SITE: Land at Cats, Leys Hill Road, Walford, Ross-on-Wye, Herefordshire HR9 5QU
TYPE: Planning Permission
DESCRIPTION: The demolition of all existing structures on the site, the permanent cessation of existing uses and the erection of five detached dwelling houses with associated garaging.
APPLICATION NO: 161689
GRID REFERENCE: OS 358664, 218820
APPLICANT: Mr Graham Mitchell
AGENT: Graham Frecknall
DATE OF THIS RESPONSE: 17th November 2016

Information added from a review of the Drainage Report received 3-11-16

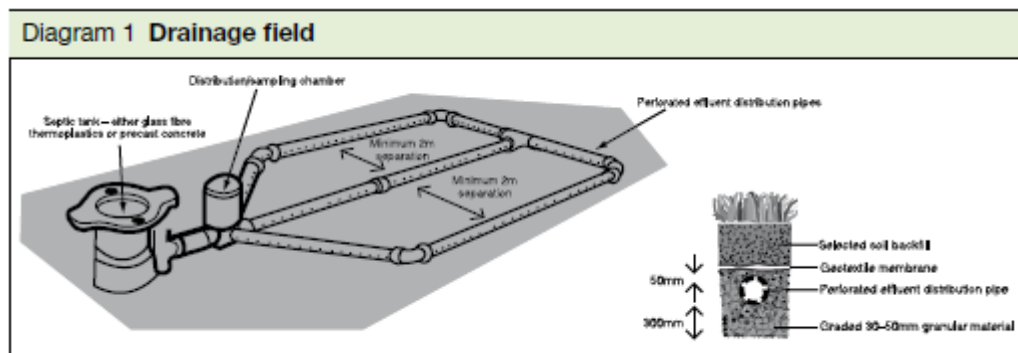
The applicant has proposed installing a soakage trench parallel with the inclined road. If kerbs are not proposed then this may work adequately. However the proposed soakage trench would conflict with the proposed package treatment plant soakage fields. Further clarification regarding this issue is required.
